Memorandum

Re: Re-submittal of Site Plan-DFT _ PR-2024-010784/SI-2024-01164

The following memo provides responses to DFT staff comments for the SOMOS Affordable Housing Plan, Site Plan-Administrative application heard on August 21, 2024. Staff comments are in italic followed by the Applicant responses.

FIRE 1
FP-24-019530

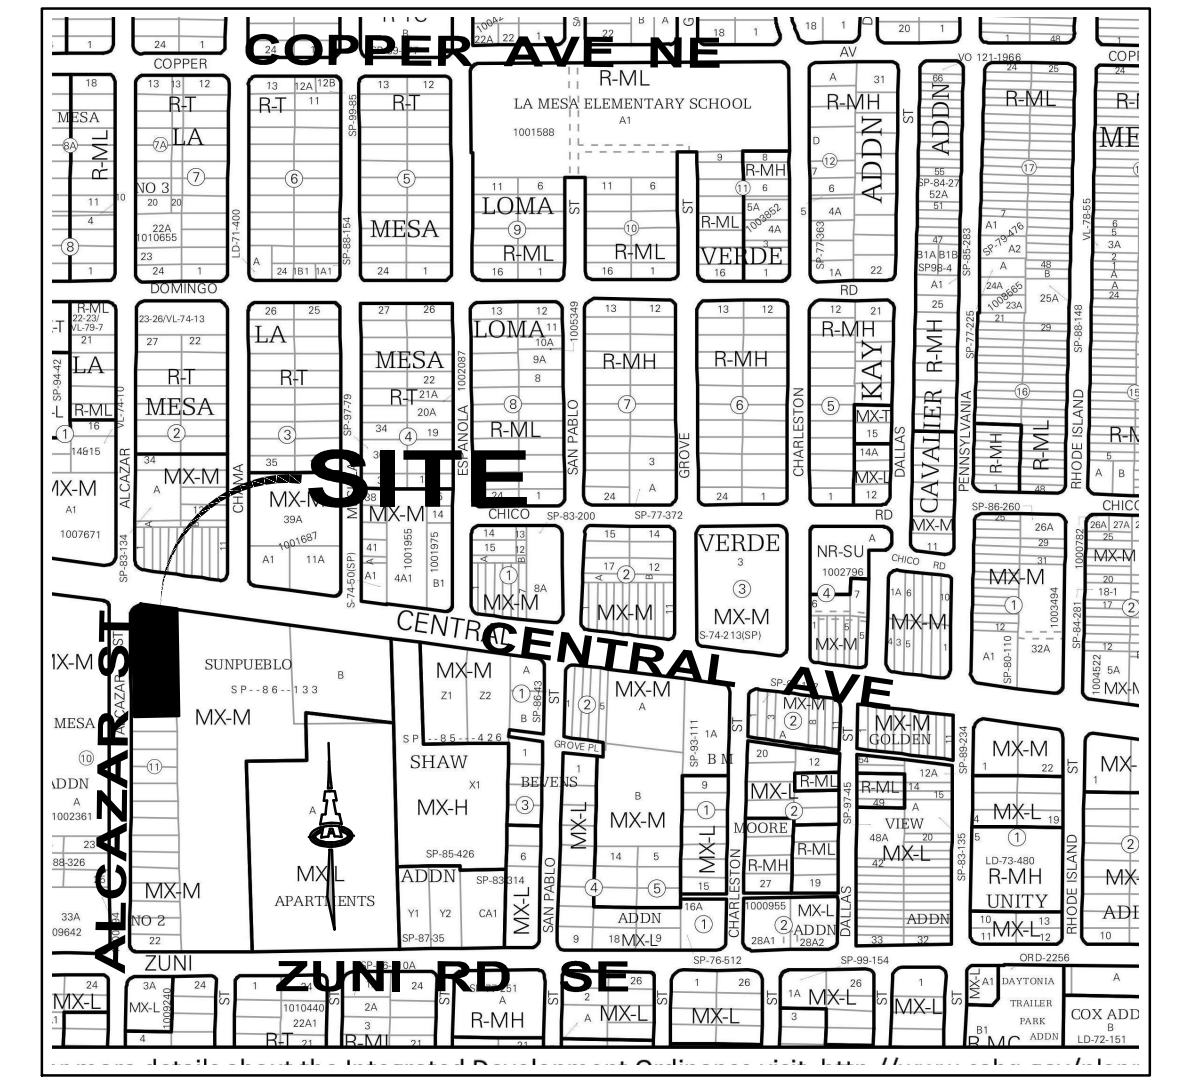
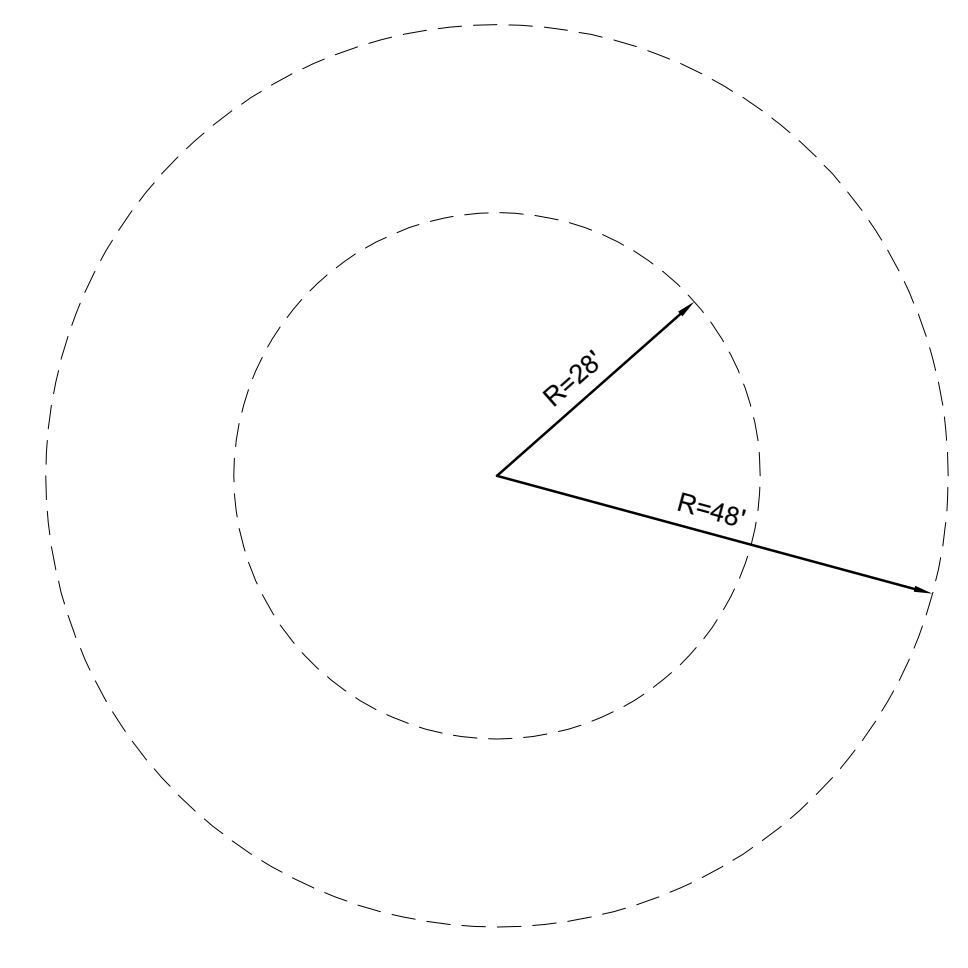
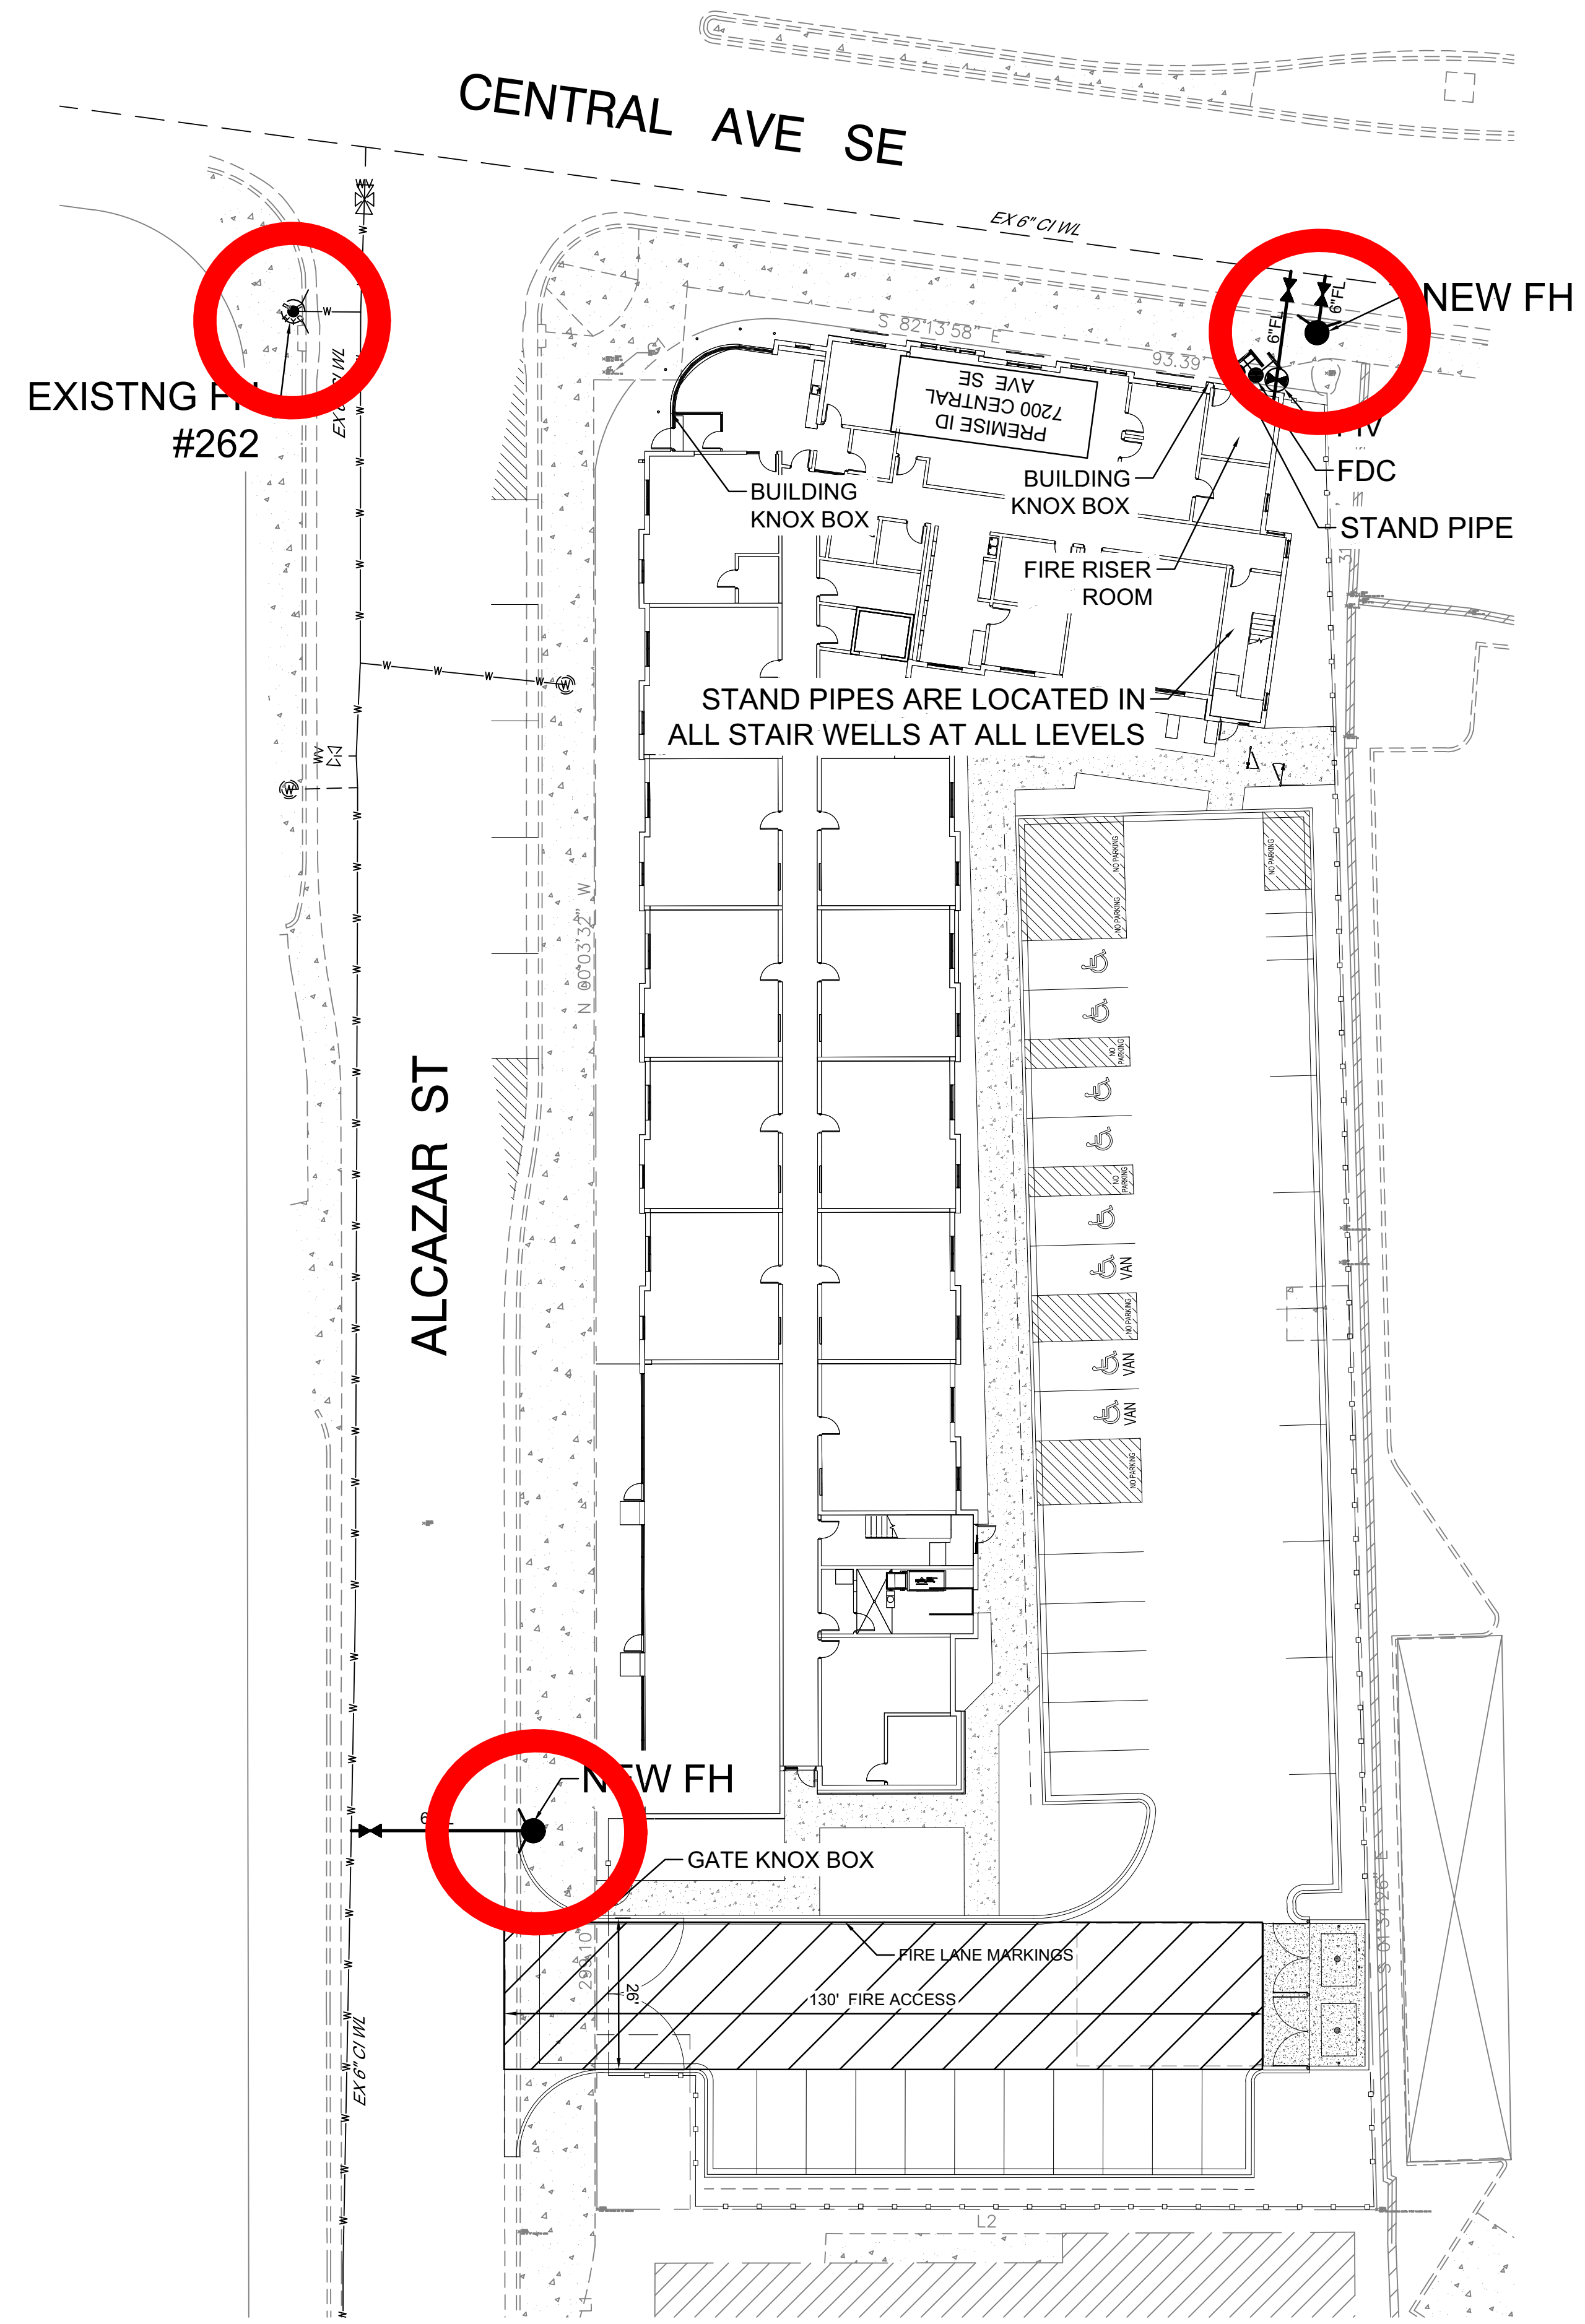
Solid Waste and Fire One approved plans are included in the Site Plan set. Fire one plan must be signed and sealed by a professional licensed in the state of New Mexico.

Applicant Response: The Fire One plan has been stamped.
